2006 Dyna Fuse Block Labels

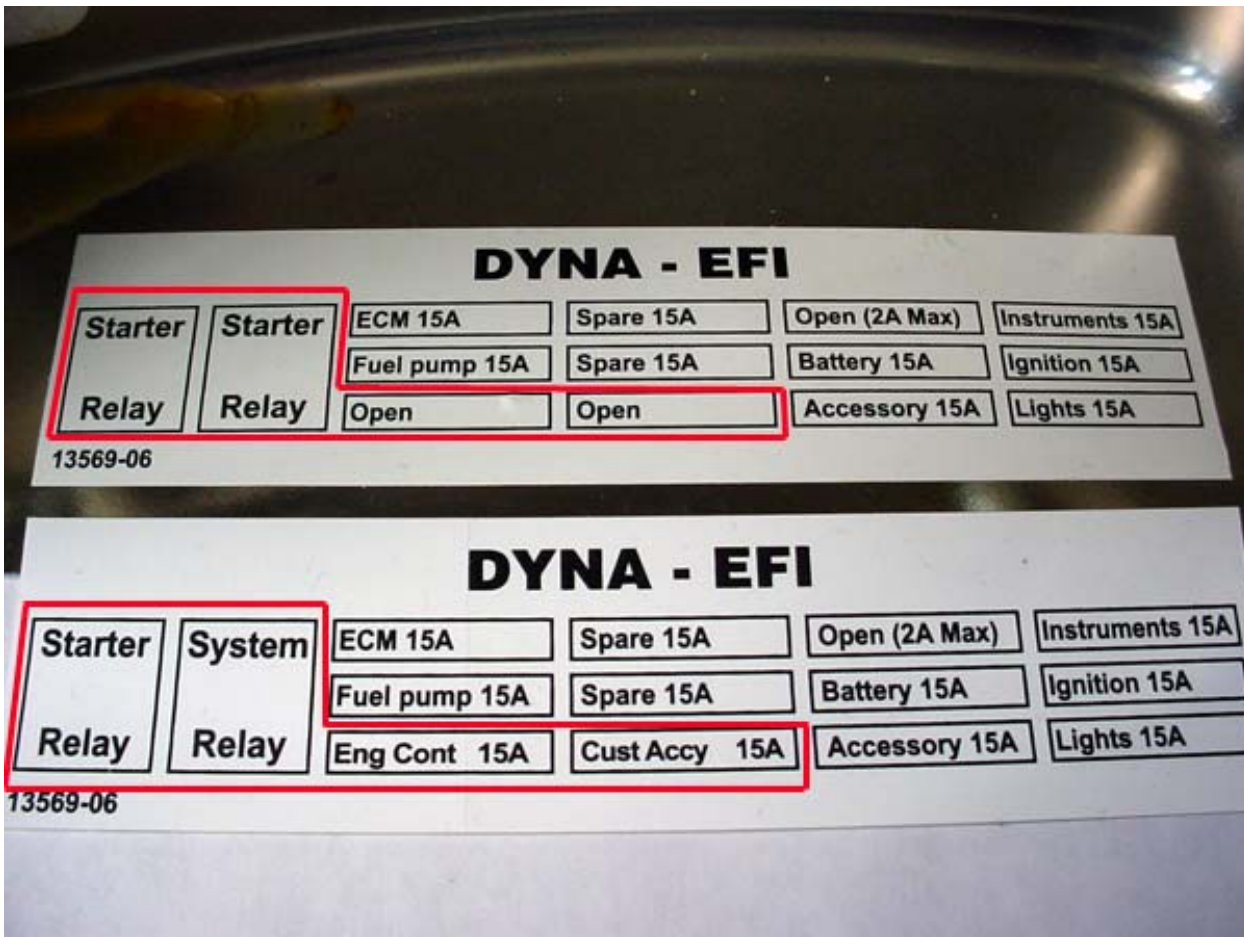
Some Dyna Models built prior to February 17th, 2006 could have the incorrect fuse block label installed in the electrical panel cover. Please check these bikes the next time they are being serviced for the correct label. If you find an incorrect fuse block label installed please replace it with a new label and file a warranty claim. The bottom label in the picture shows the correct label for all 2006 Dyna models. The top picture shows the incorrect label. **If the sticker needs to be replaced you can file a warranty using labor code 8888 for 0.1hrs which includes admin time.**
